REPORT TO THE CALGARY PLANNING COMMISSION

DEVELOPMENT PERMIT	ITEM NO: 06	
	CPC DATE:	2007 November 15
	DP NO:	DP2007-1120

PROPOSAL: Mixed Use Apartment Building (254 Units), with office and retail uses.

APPLICANT: Poon McKenzie Architects	OWNER: Resiance Corporation
MUNICIPAL ADDRESS: 731 and 739 – 10 Avenue SW	LEGAL DESCRIPTION: Plan A1, Block 67, Lots 1 to 6 (Map 16C)
EXISTING LAND USE DISTRICT(S):	DC Direct Control District (43Z2006)
AREA OF SITE: 0.18 ha ± (0.44 ac ±)	
CURRENT DEVELOPMENT:	Single Storey commercial Buildings

Apartment Building (240 Units) with Maine  
Floor Commercial (Gateway Beltline)

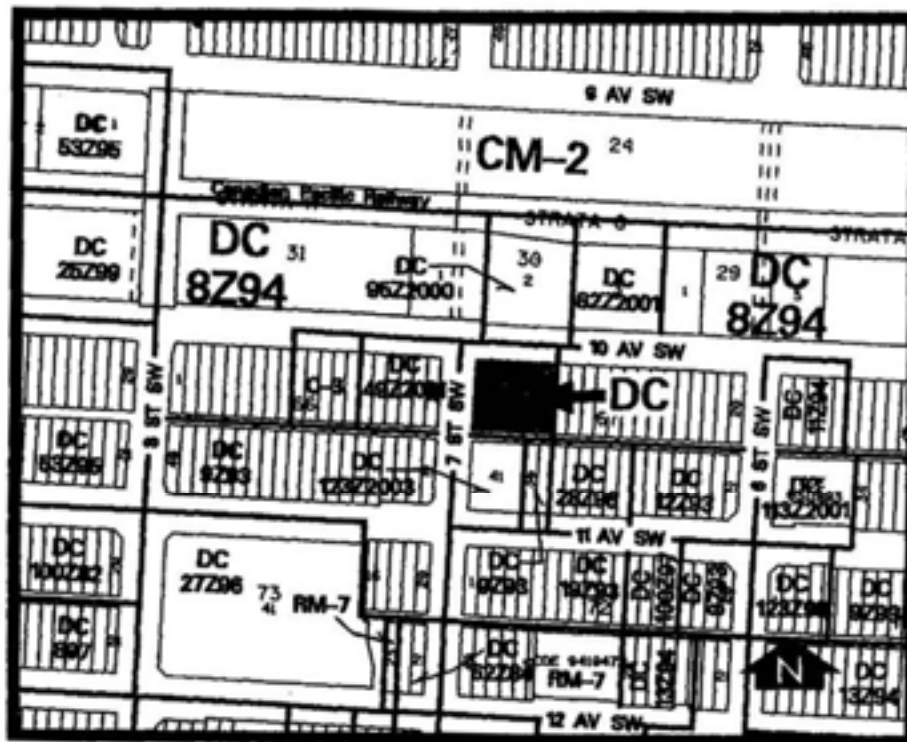
- The Panel is concerned with the lack of a detailed context plan which clearly shows adjacent lands and proposed new developments in the vicinity of the project;

- The Panel questions the use of a historic theme for the podium design and encourages the applicant to keep the design in character with the of the rest of the project (and not with the adjacent buildings);

- The Panel is concerned with the canopy and encourages the applicant to extend the west canopy to provide increased pedestrian protection;
- The Panel encourages the developer to seek small- scale tenants (minimum of two) for the main floor;
